Subject: Los Esteros Critical Energy Facility Application for Certification
Data Request Set #1 Response (01-AFC-12)

**Los Esteros Critical Energy Facility
(01-AFC-12)**

Data Request Set 1

**Los Esteros Critical Energy Facility
Data Request Response Set 1
(01-AFC-12)**

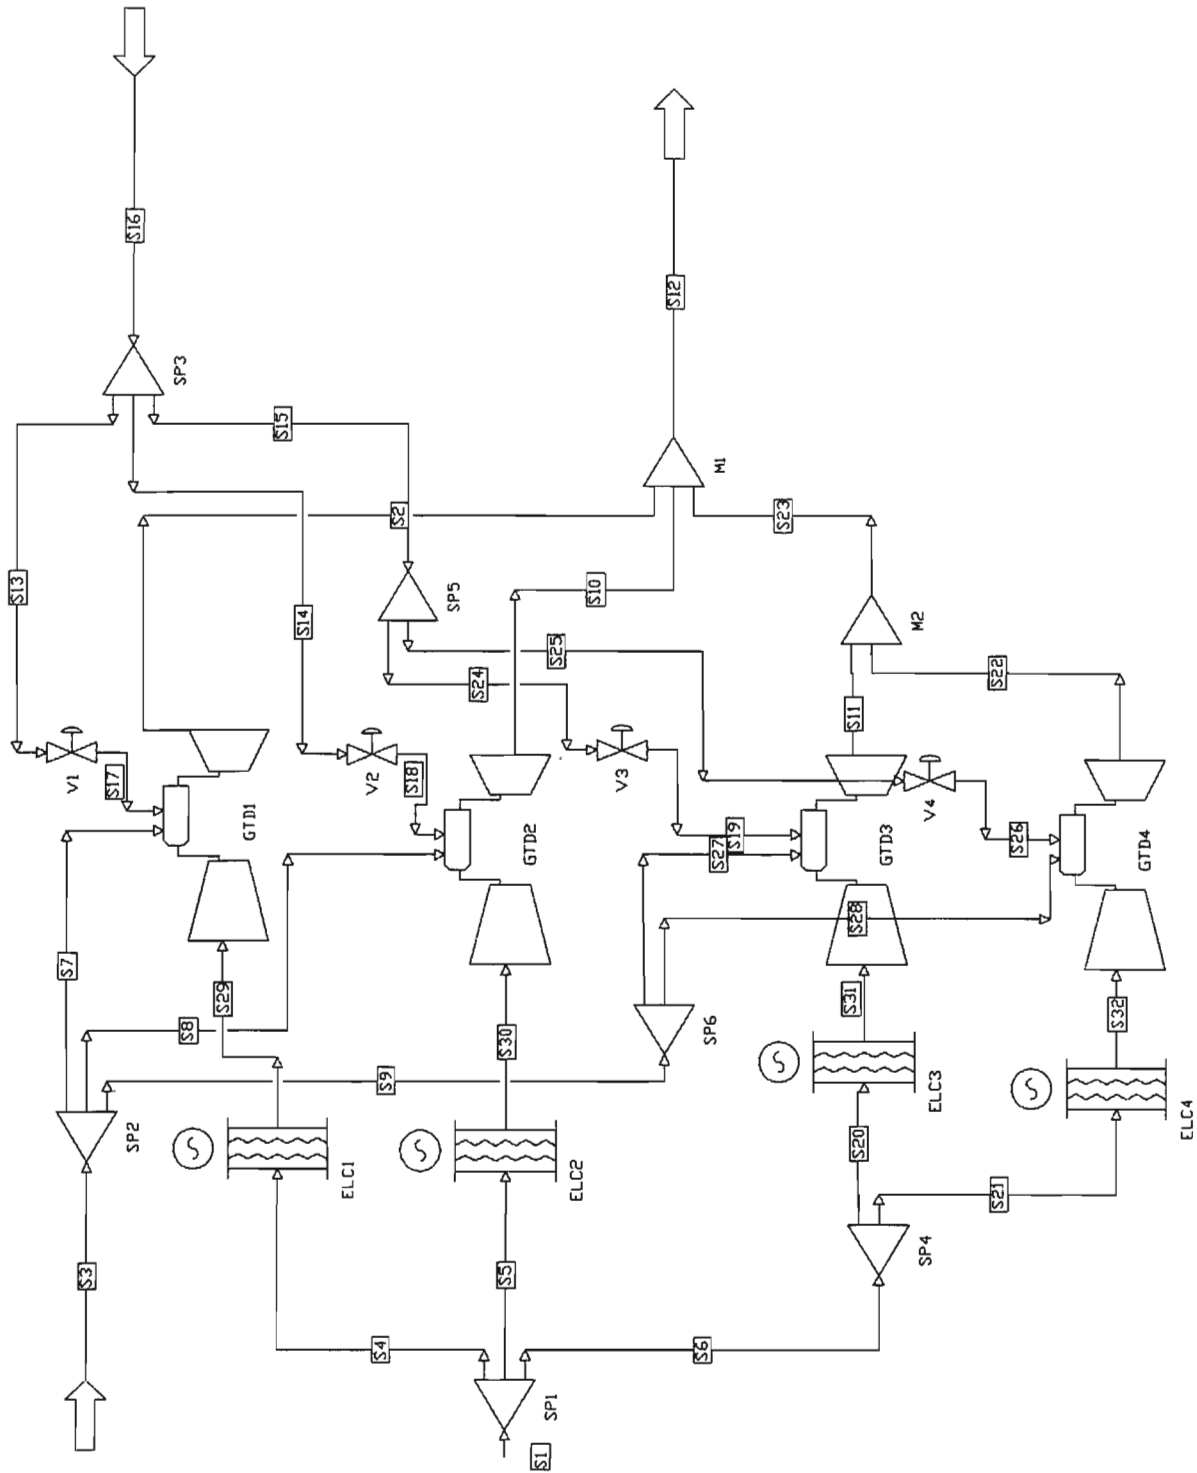
The Heat and Mass Balance Diagram bears the information required to analyze project fuel efficiency and, thus, its impacts on energy resources. Figure 2.2-3 of the AFC is such a Heat and Mass Balance Diagram. However, the copy included in the AFC is largely illegible.

29. Please provide a legible copy of Figure 2.2-3, Heat and Mass Balance Diagram.

Response: A legible copy of the project's heat and mass balance, based on the GateCycle software is presented in Attachment EFF-1.
